Announcement of IFT Rank Marking Additional on Toshiba Photocoupler Actual Product

- ① TLP267J (\*\*\*(T                      ② TLP268J (\*\*\*(T  
 (Manufactured by Toshiba Semiconductor (Thailand) Co., Ltd.)

H. Matsuo / Manag  
 Quality Planning Group  
 Quality Assurance Department  
 Buzen Toshiba Electronics Corporation

表 トリガーLED電流ランク (注) (特に指定のない限り, T<sub>a</sub> = 25 °C)

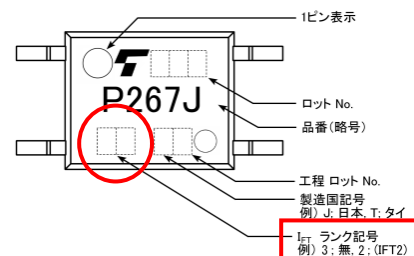
No Rank Product: The rank identification symbol on the product should be "3" ← the actual product identification: "3" does not exist (mismatched)

IFT2 Rank Product: The rank identification symbol on the product should be "2" ← the actual product identification: "2" (Matched)

## Marking Symbol of Target Products

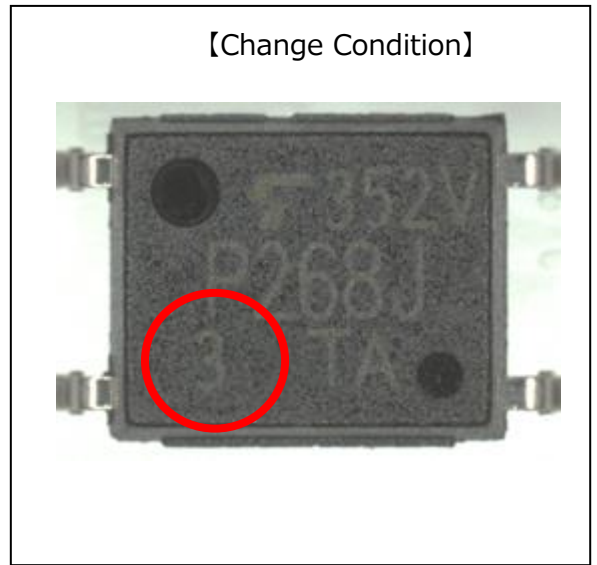
"3" will be added as marking symbol on the actual product for product with no rank which is trigger LED current (IFT). (Please refer to next page)

Marking "3" for the IFT rank identification symbol on the actual product will be shown as above.
